Access Compliance Report

Public Rights-of-Way

Intersection ID: 12902	Main Street: HALL_AV	Cross Street: NASSAU_BV	Location: SE
ADA ID: 4E06324C275A	Ramp Type: Directional1	Initial Pass/Fail: Fail	Overall Compliance: No
			Severity Score: 26.25

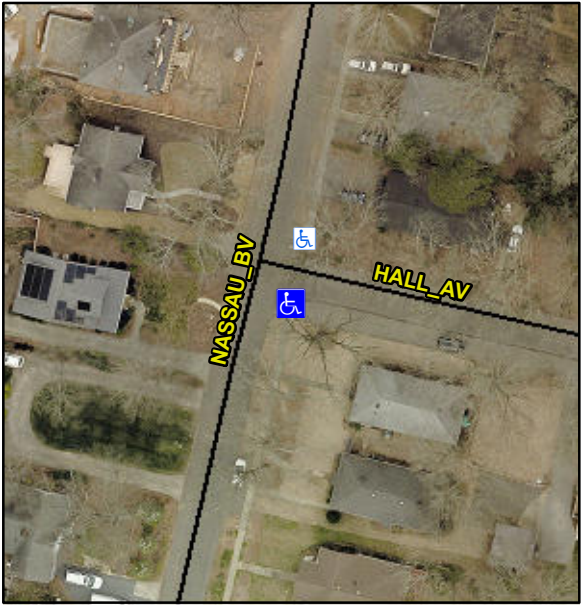
Codes/Mitigation Info/Possible Solution			Field Measurements/Component Compliance			
 <p>Street 1 Name: HALL AV</p> <p>Stop Condition-Street 1: StopSign</p> <p>Street 2 Name: N/A</p> <p>Stop Condition-Street 2: N/A</p>	Possible Solutions:		Compliance	Description	Data	
	Remove & Replace Entire Ramp.		N/A	Ramp Length (in)	98.0	N/A
			Yes	Ramp Width (in)	49.0	N/A
			No	Ramp Slope (%)	14.9	N/A
			No	Ramp XSlope (%)	3.7	N/A
			N/A	Flare Type LT	N/A	N/A
			N/A	Flare Slope LT (%)	N/A	N/A
			N/A	Flare Traversable LT?	N/A	N/A
			N/A	Landing Length (in)	0.0	N/A
			N/A	Landing Width (in)	0.0	N/A
			N/A	Landing Slope (%)	0.0	N/A
			N/A	Landing X Slope (%)	0.0	N/A
			N/A	Landing Curb? (Y/N)	N/A	N/A
			N/A	Shared Landing?	N/A	N/A
			N/A	Gutter Ponding?	0.0	N/A
			N/A	Gutter Lip Ht (in)	0.0	N/A
			N/A	Painted X Walk1?	No	N/A
				X Walk 1 Direction	To N	N/A
				X Walk 1 Width (in)	N/A	N/A
				X Walk 1 Slope (%)	13.3	N/A
				X Walk 1 X Slope (%)	1.2	N/A

R304.2.2, R304.5.3

Remove & Replace Entire Ramp.
